HYDRAULIC LABORATORY REPORT NO. 168

INVESTIGATIONS OF THE HYDRAULIC PROPERTIES OF THE REVISED HOWELL BUNGER VALVE CITY OF SEATTLE, WASHINGTON

Subject: Investigations of the hydraulic properties of the revised Howell-Bunger valve, City of Seattle, Washington.

FIGURE 1

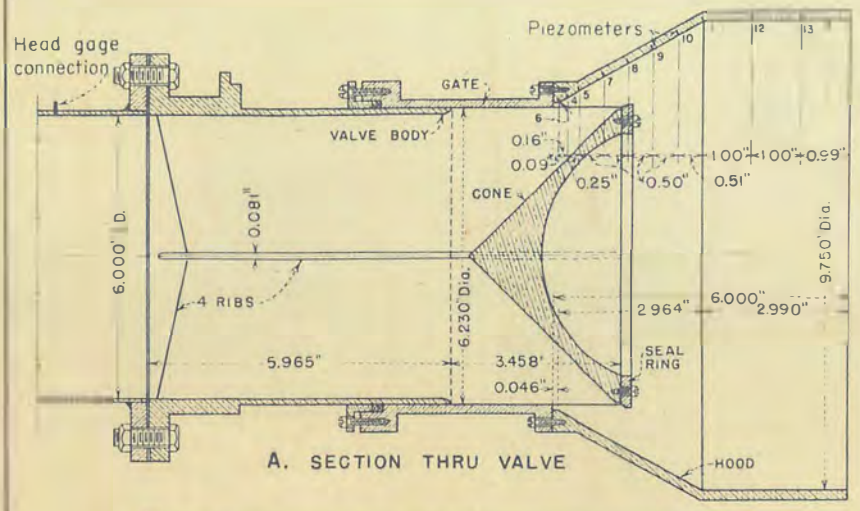
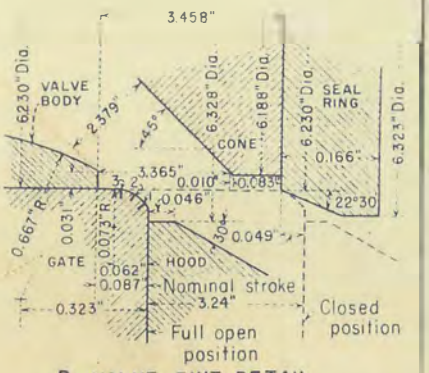
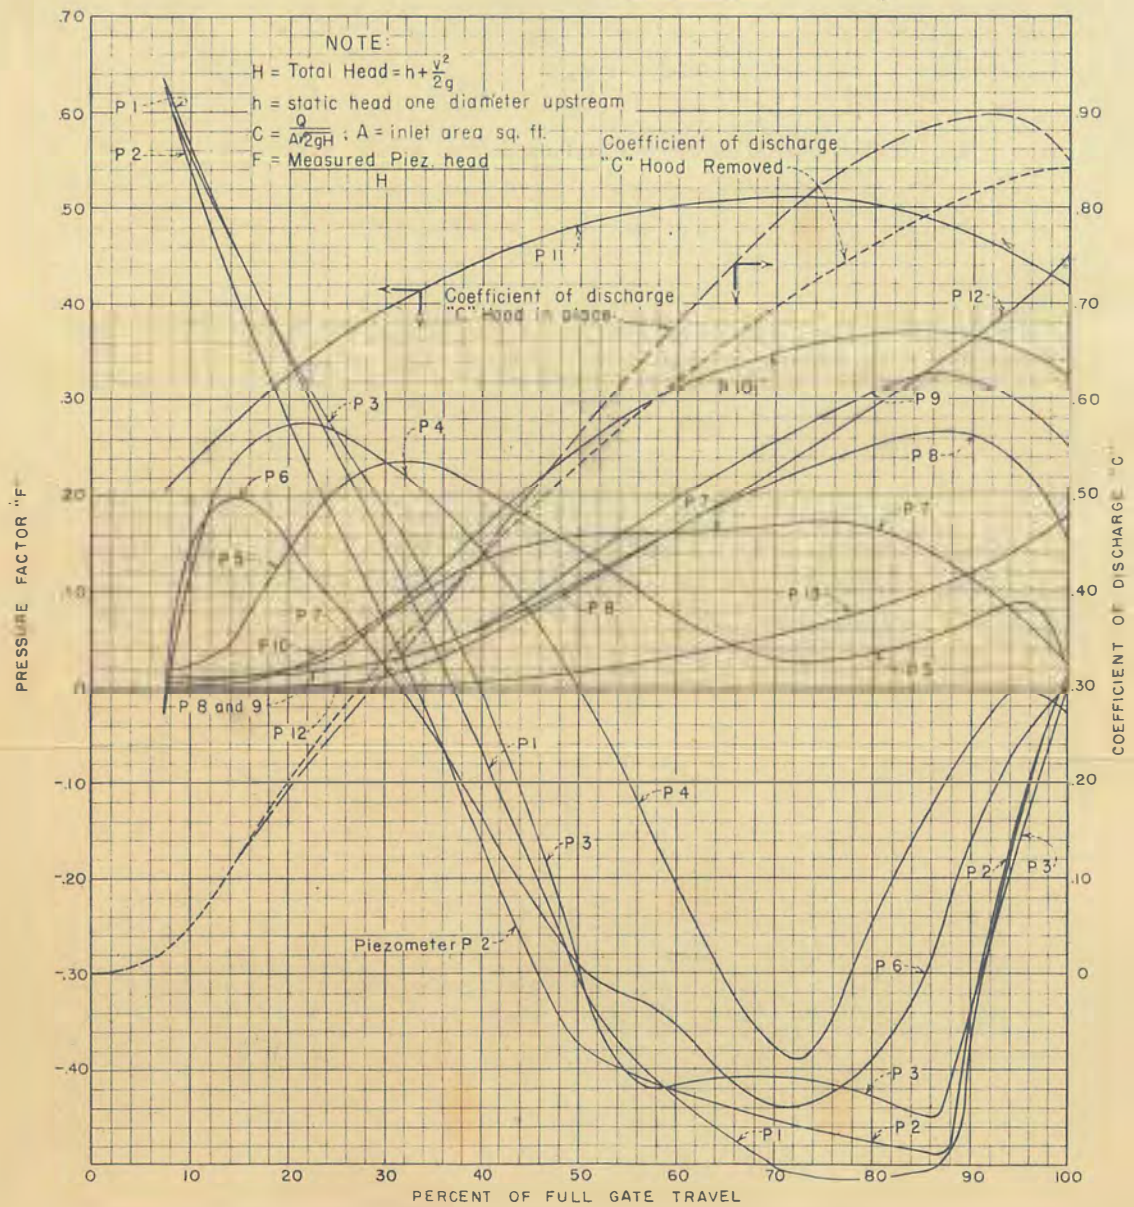
2. The model. The 6-inch bronze model valve of the previous tests was revamped, figure 1, to conform with the dimensions furnished by letter from S. Morgan Smith Company dated March 2, 1945 (appendix A). The changes involved loosening the ribs and moving the cone forward to provide more clearance between the valve body and the seat, remachining the downstream face of the cone, decreasing the base diameter of the cone, changing the angle, diameter, and thickness of the seat ring, and making a completely new hood. The alterations on the valve, with the exception of the hood, were minor, being of the magnitude of a few hundredths of an inch.

3. Results of tests discharging into the atmosphere with hood. The valve was assembled as shown in figure 1 and placed on the test line with suitable piezometer connections, as indicated in the figure by

numbers, to a manifold and mercury gage and then tested with the valve set at various openings between zero and full-open position. The results are shown in figure 1C where the pressure factor F and the coefficient of discharge C have been plotted against percent of full-valve opening.

The pressure factor F has been defined in figure 1 as the ratio of the measured piezometer pressure to the total head (static head plus velocity head) one inlet diameter upstream from the valve. This reduces F to a dimensionless number, making it possible to obtain the pressure at a point on the valve by selecting from the curves the value of F and multiplying it by the total head one inlet diameter upstream. As an example, to find the pressure at piezometer 8 when the total head is 200 feet of water and the gate 60 percent open, follow the 60 percent line until it intersects curve P8, figure 1, and read the value of the pressure factor at the left which in this case is 0.165. Multiply 200 times 0.165 and the resulting pressure is 33.0 feet of water. Likewise the pressure at piezometer 4 is -41.0 feet of water. As this pressure is unattainable, the result indicates that vapor pressure of water or the maximum negative pressure corresponding to the existing atmospheric conditions will exist in the prototype and pitting due to cavitation may be expected with heads of this magnitude. Actually, the pressure factor curves show that the vapor pressure of water will exist at much lower heads than 200 feet of water. Curves P1, P2, P3, and P6 show pressure factors below -0.40 which indicate that the vapor pressure of water will exist at these points with heads as low as 75 feet of water and gate openings between

The coefficient of discharge, C, reaches a maximum value of 0.895 at 92 percent of full gate and falls back to 0.850 at maximum opening. The high coefficient obtained at partial openings was due to the negative pressures which prevailed at the valve seat and on the hood. Since the scaled negative pressures are beyond the vapor pressure of water under reasonably high heads, the coefficient of 0.895 will not occur in the prototype and the value of 0.85 is probably more nearly the correct value for the prototype.

6. Conclusions. As far as could be determined from the model, it appears that positive pressures will exist on all parts of the valve for free discharge without the hood attached. It was not possible to obtain pressures on the 0.667-inch radius at the downstream end of the valve body, figure 1B. It cannot be stated that positive pressures will exist on this part of the valve.

FIGURE 2

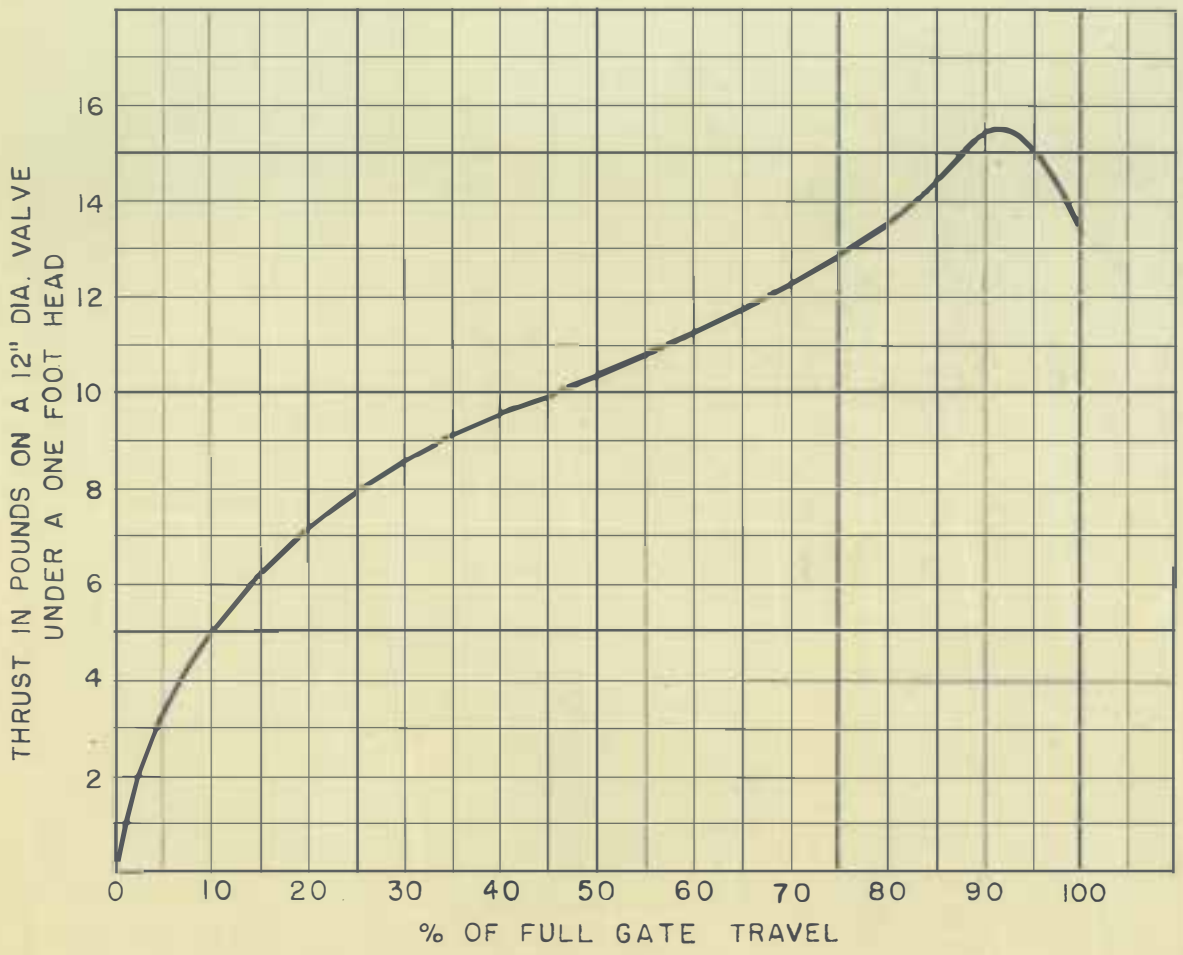
The use of the hood on this valve creates an unbalanced thrust on the valve which acts opposite to the direction of flow. The magnitude of the force has been computed by integrating the results of the pressure measurements in the valve and hood (see appendix A). These values have been reduced to the force on a 12-inch valve, under a 1-foot head to simplify the computation of the thrust on a valve of any diameter, figure 2. The prototype thrust can then be obtained from the formula, $T = n^2Ht$, where n = valve diameter in feet, H = total head in feet of water one diameter upstream from the valve, t = a thrust value selected from figure 2 for a particular valve position.

The maximum unbalanced thrust for a 72-inch valve amounts to 55,800 pounds per 100 feet of head. This does not include the balancing effect of the friction drag of the water on the boundaries. However, this is small and is estimated to be no more than four percent of the maximum thrust.

The thrust obtained with this hood is considerably less, 55,800 pounds as compared to 94,250 pounds for the hood used in the tests described in HYD-156. The decrease is due partly to the increased negative pressures and partly to the fact that the jet was not turned through the entire 45 degrees but left the valve diverging at a central angle of approximately 20 degrees. Had the jet emitted parallel with the valve axis as it did with the smaller hood of the previous design, the thrust would have been larger and the severity of the negative pressures somewhat decreased.

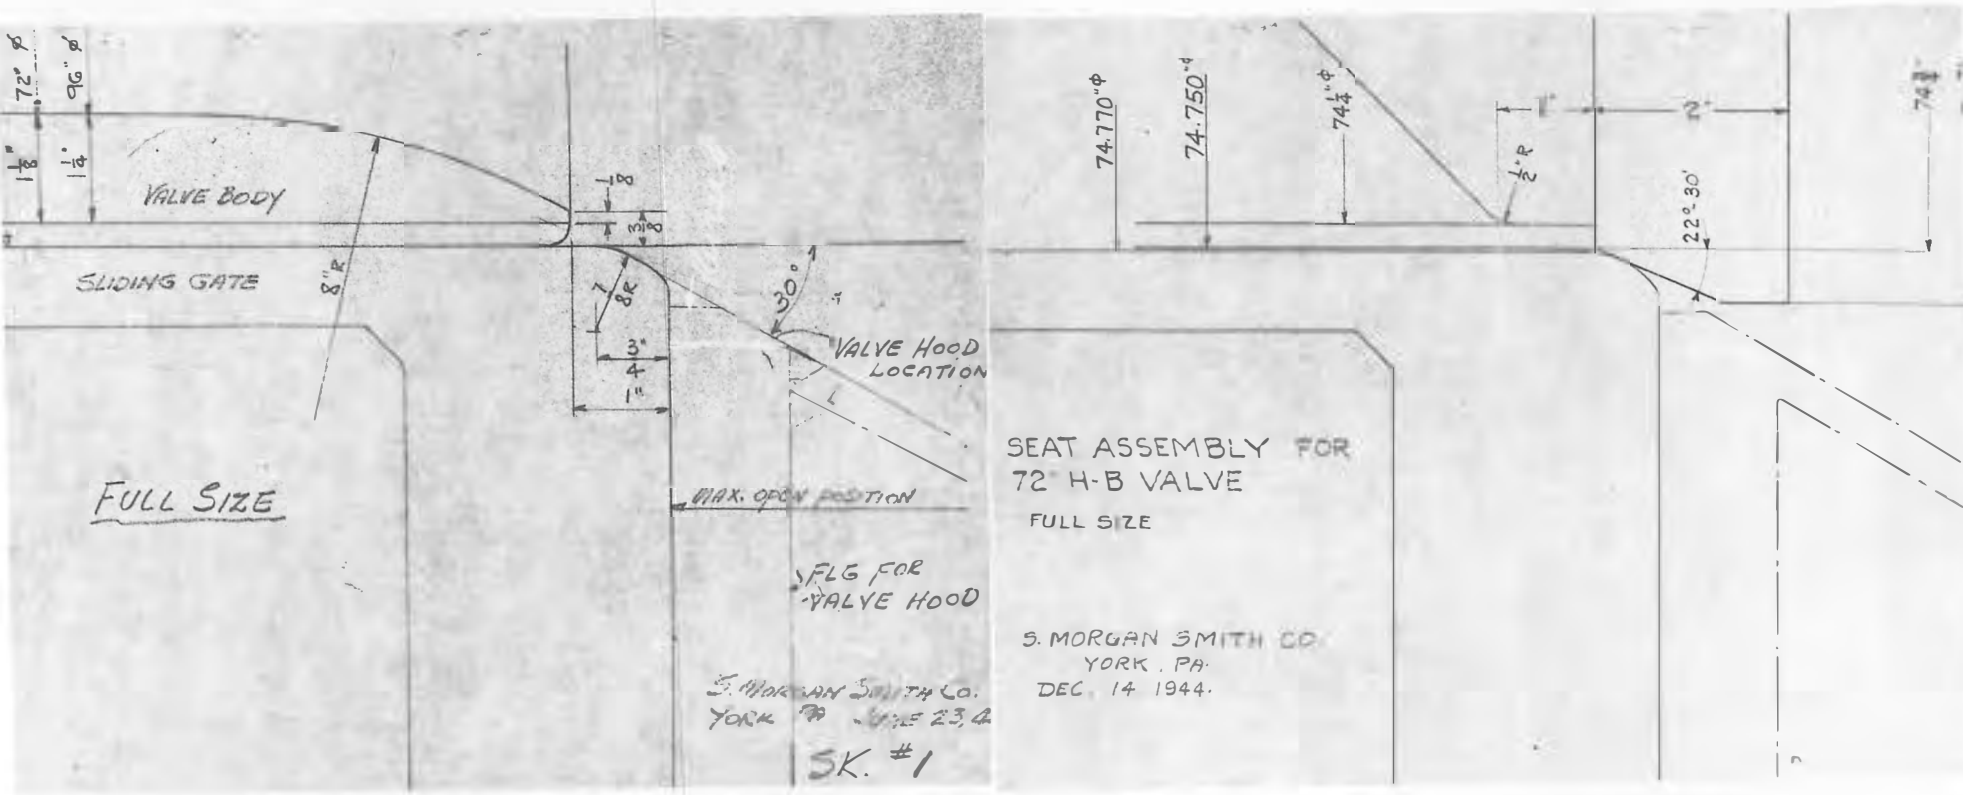
A thorough check-up by our Engineering Department shows that a regrettable error had occurred on our part when we furnished Mr. Warnock with details of the hood for a 72" valve on June 23, 1944. About the only excuse we can offer for this mistake is the rush of wartime contracts and the shortage of manpower in our Design Department. The dimension of 104" for the inside diameter of the hood which we furnished Mr. Warnock should have been 117", which would change the 6" model hood from 8.667" as shown to 9.75". These correct dimensions are proportioned from the 6½" inside diameter of the hood for the 4" model valve designated Hood for Test No. 5, our "Report on Tests of Various Discharge Hoods for Restricting the Spray on the Howell-Bunger Valves", a copy of which is enclosed. We also note that insufficient information in regard to the end seal plate and downstream end of the valve caused some inconvenience. We would have been glad to furnish this information upon notification. There is a slight variation from the 6" model parts used, from the prototype, which would change the outside diameter of the model seat ring from 6.550" diameter to 6.525" and the thickness from .188" to .186", with the angle on the seat changed from 30 degrees to 22½ degrees. Two (2) blue prints showing the seat assembly, full size, for the 72" Howell-Bunger valve, dated December 14, 1944, are enclosed. Also enclosed are two revised prints from Sketch No. 1, dated June 23, 1944, showing, full size, the sliding gate in full open position, for a 72" valve.

The sketches submitted by you to date have not included a complete detail of the seating area on the gate. Sketch S.K. No. 1, copies of which were included in your June 23, 1944, and January 2, 1945, letters, shows a different design from that on "Seat Assembly for 72-inch Howell-Bunger Valve" dated December 14, 1944.

The drawing, "Seat Assembly for 72-inch Howell-Bunger Valve," dated December 14, 1944, shows a diameter of 74-1/4 inches for the base of the conical section, whereas all other drawings indicate this dimension to be approximately 74-3/4 inches.

FIGURE 3

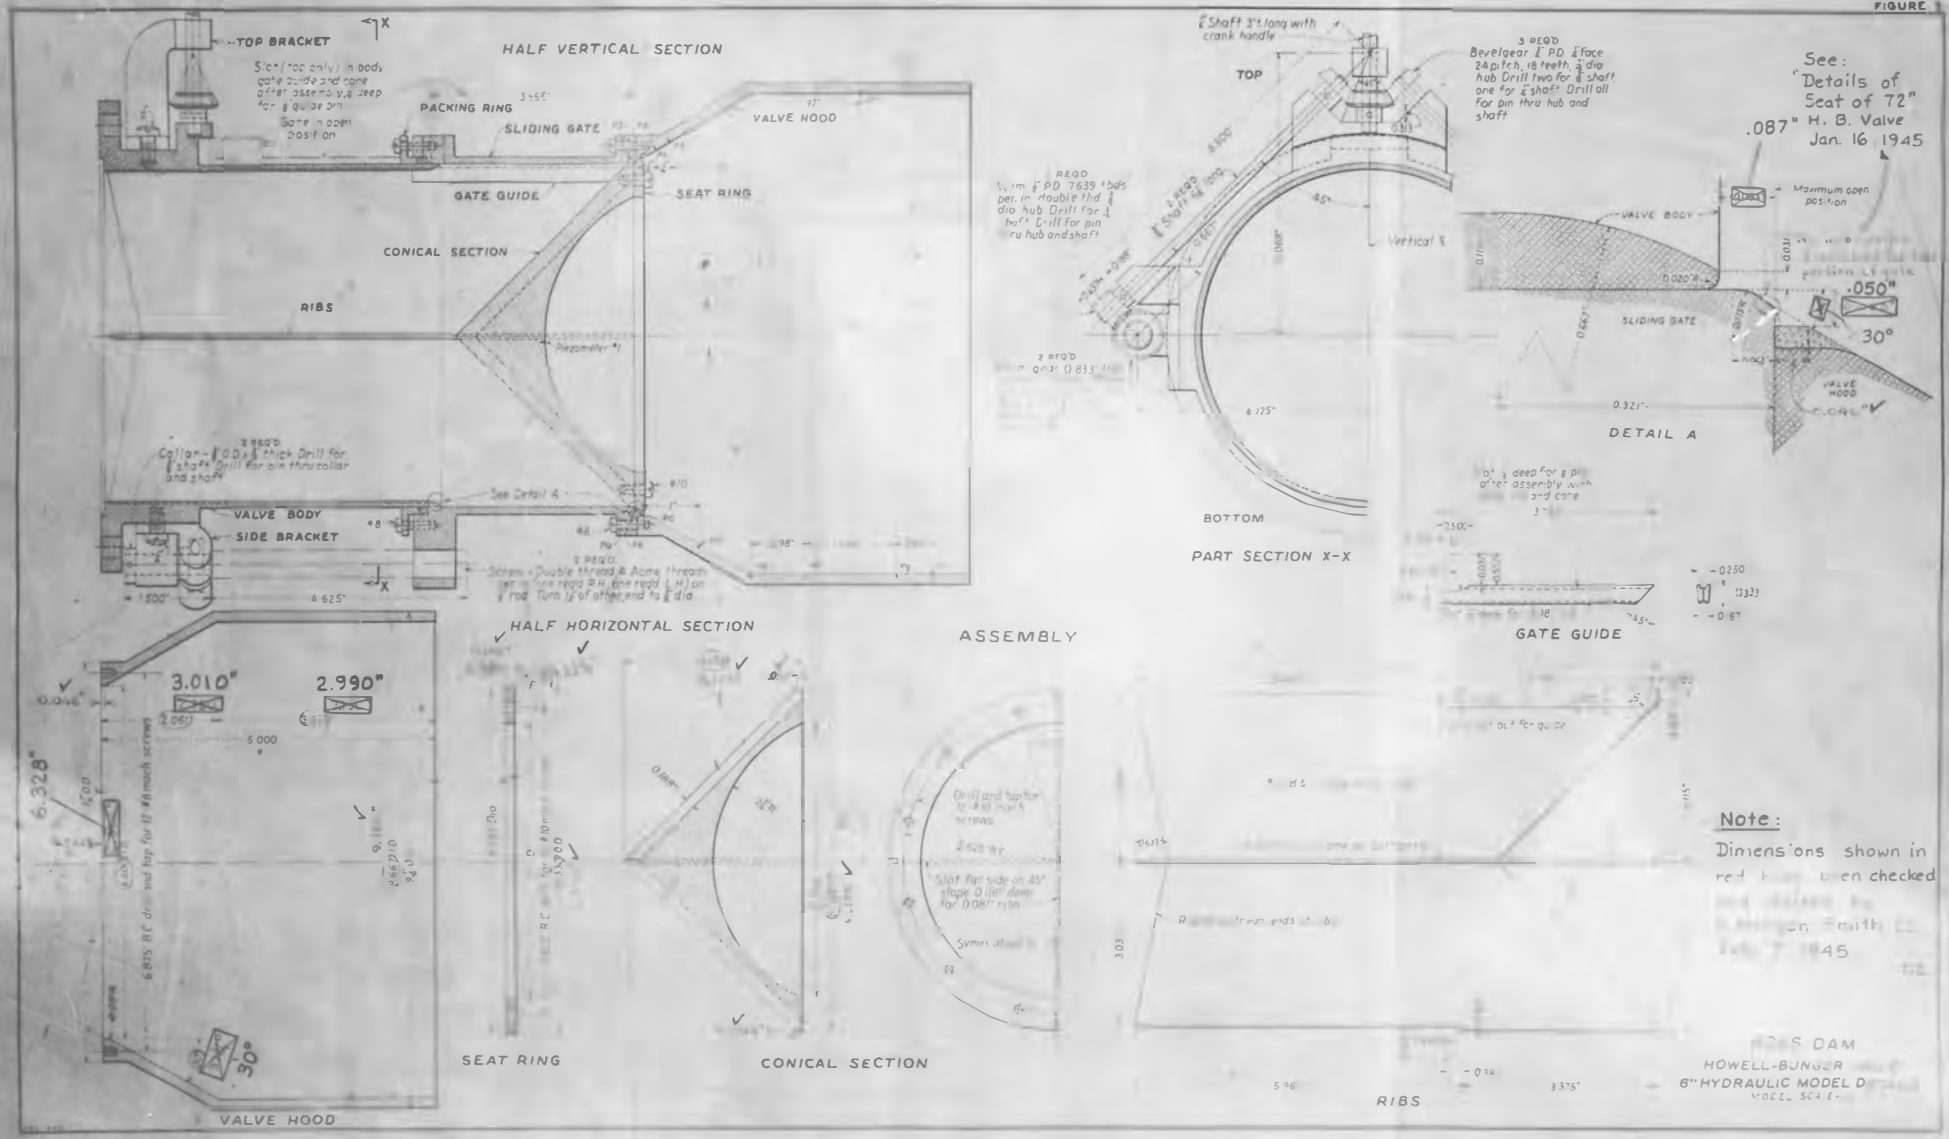
Referring to your drawing, Figure 3, you will note that we have checked your figures in red and made several corrections. On the cone, we believe it unnecessary to reduce the diameter to 7.6158" for the new test, as it will not affect the discharge, with a larger hood of proper dimensions, as occurred before with the incorrect hood diameter. The radius of the gate as per detail A of .073" should be drawn to intersect with the end of the gate and should not be tangent to the 30° line. The center of the radius is correctly shown.

The cone angle of the valve hood should be 30° as corrected.
